Value Engineering Study
***US 127 FROM KY 90 TO
JAMESTOWN BYPASS***
CLINTON & RUSSELL COUNTY, KENTUCKY

***ITEM NUMBER 8-108.00 & 8-115.10
VE STUDY NUMBER 201102***

Study Date: February 28 -
March 4, 2011

Final Report

SKETCH OF RECOMMENDED DESIGN

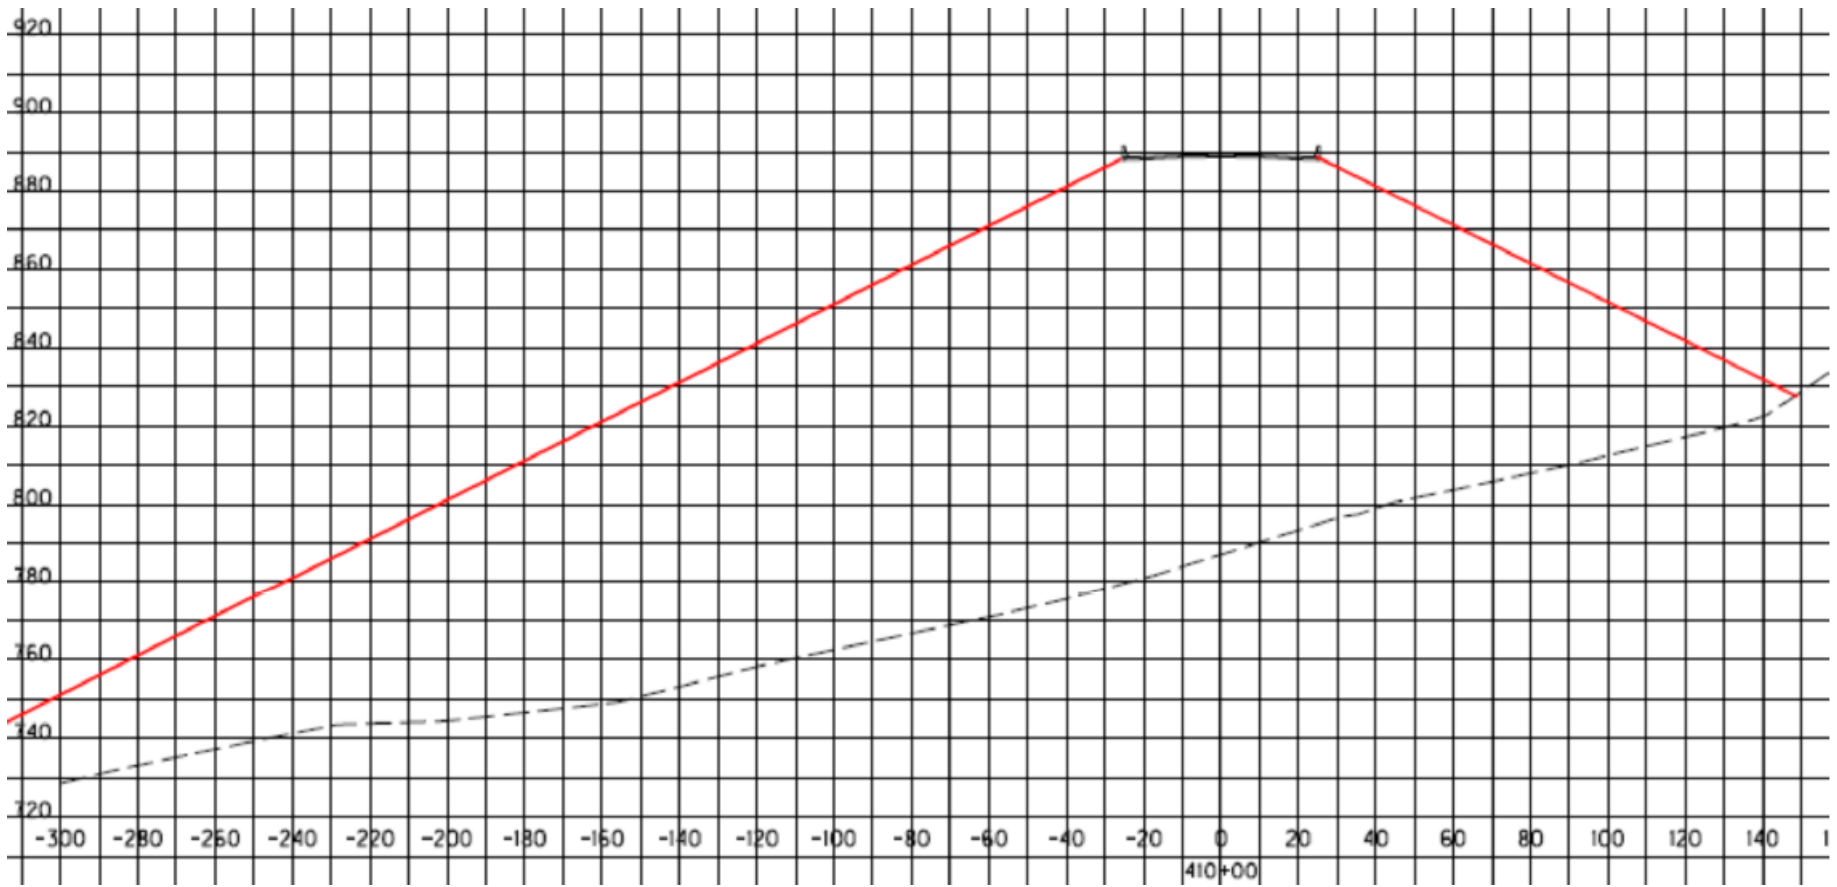
The original design specifies a bridge spanning West Fork Creek and the associated valley. Based on preliminary recommendations the estimated bridge length is 753 feet with a 51 foot bridge width. The valley at this location is approximately 200 feet below the profile grade for US 127. Based on the required pier height for this structure the VE team revised the project team’s square foot costs for the bridge to \$275 per square foot from \$105 per square foot to reflect the increased span lengths and complexity of constructing tall piers.

The revised initial construction costs are significantly reduced by eliminating the proposed structure in lieu of a culvert structure and embankment. A secondary benefit would be the elimination of future deck overlays/replacement, painting, and other bridge maintenance items. This VE proposal assumes a fill cost of \$6 per square foot. While not studied as part of this recommendation, adjusting the profile to reduce the depth of fills and better balance the overall cut fill for the project would increase the benefit of this VE recommendation.

VALUE ENGINEERING RECOMMENDATION # VE-17

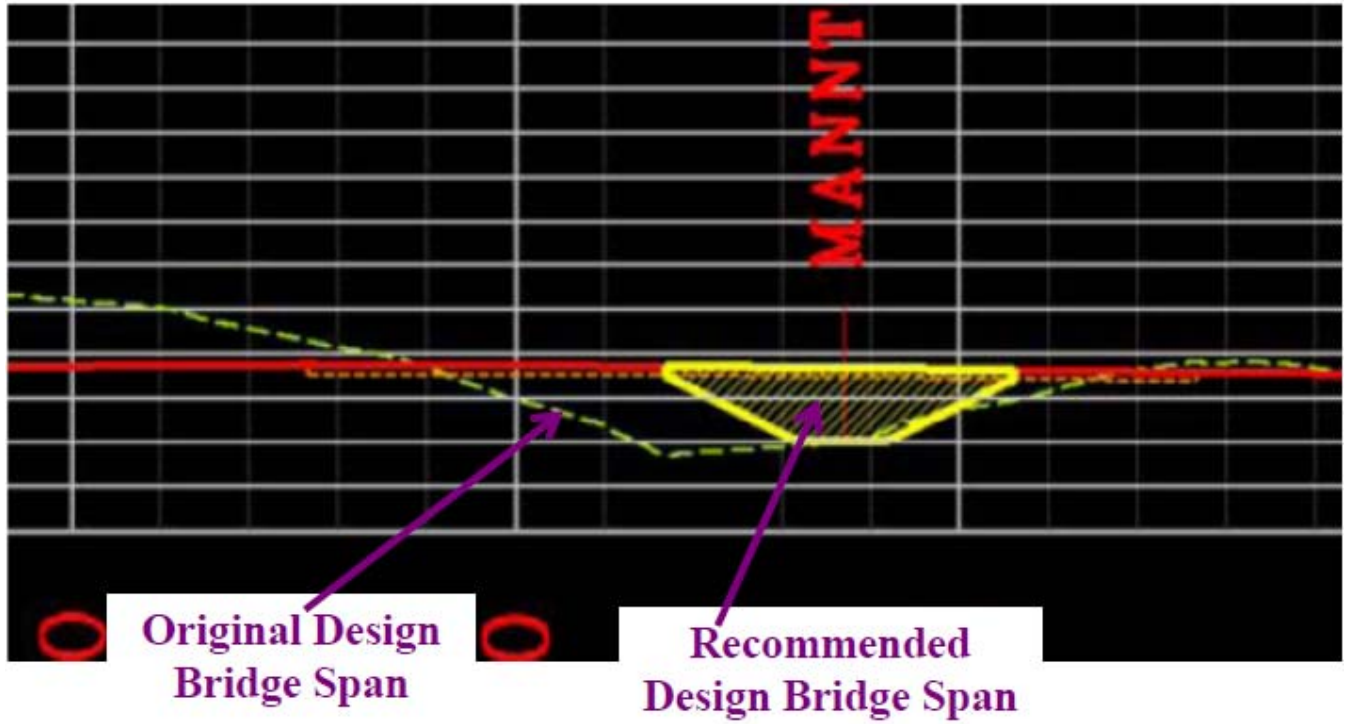
The VE team recommends extending the roadway and embankment on the ends of the bridge to reduce the overall bridge length. Three bridges appear to be good candidates for this modification:

The original design estimated all the bridge structure at \$105 per square foot. These bridges cross valleys that range from 50 to almost 100 feet deep. Based on the height of the required piers, the VE team is of the opinion that more realistic costs range from \$150 to \$175 per square foot for these bridges. Refer to the attached estimates for more detail. These increased unit costs accounts for the complexity of constructing taller piers and the associated effects on superstructure selection.

The revised initial construction costs are significantly reduced by shortening the proposed structures. No significant changes to the life cycle costs are anticipated.
